MEMO

To: Kristopher Byrd, Well Construction and Compliance Section Manager
From: Tommy Laird, Well Construction Program Coordinator
Subject: Review of Water Right Application G-19172
Date: June 2, 2022

Groundwater Application Review Summary Form

Application # G- 19172

Stream Depletion Modeling

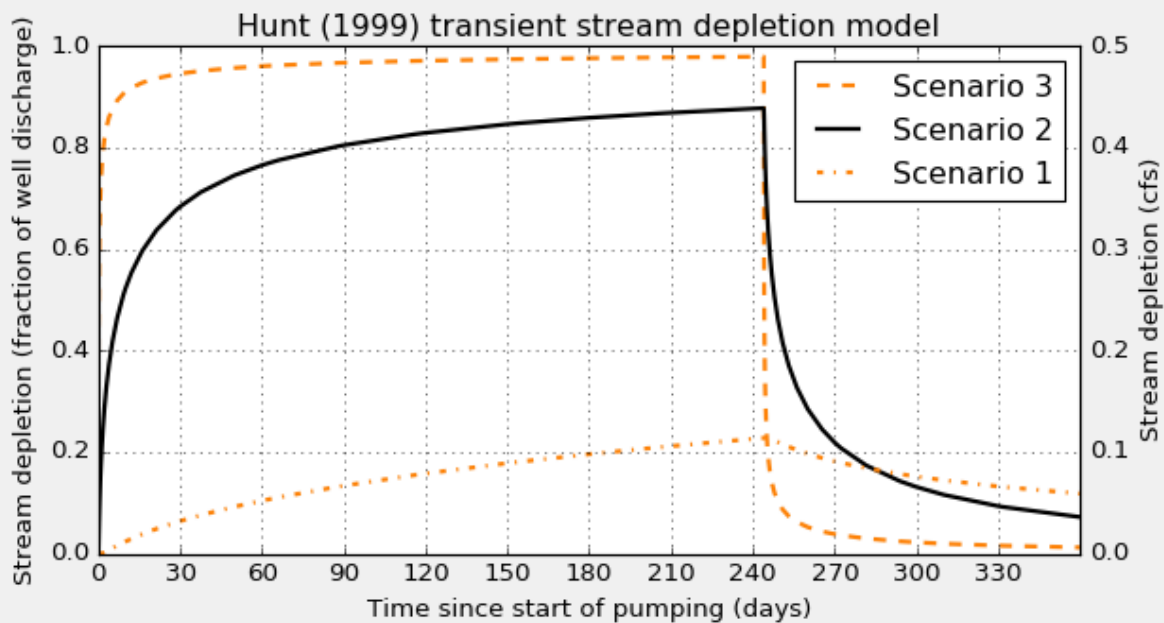
C6. **SW / GW Remarks and Conditions:** The applicant's well accesses an aquifer that is determined and assumed to be hydraulically connected to Pleasant Creek. The proposed use is found to have the Potential for Substantial Interference (PSI) with Pleasant Creek by the following metrics as outlined in OAR 690-009: the well is located within ¼ mile of a surface water source, the requested rate (0.045 cfs) is larger than 1% of the expected natural stream flow (1% of 0.35 cfs or 0.0035 cfs), the requested rate (0.045 cfs) is larger than 1% of adopted instream flow (1% of 0.52 cfs or 0.0052 cfs), and the estimated stream depletion after 30 days is greater than 25%. Reducing the requested rate will not avoid a finding of PSI.
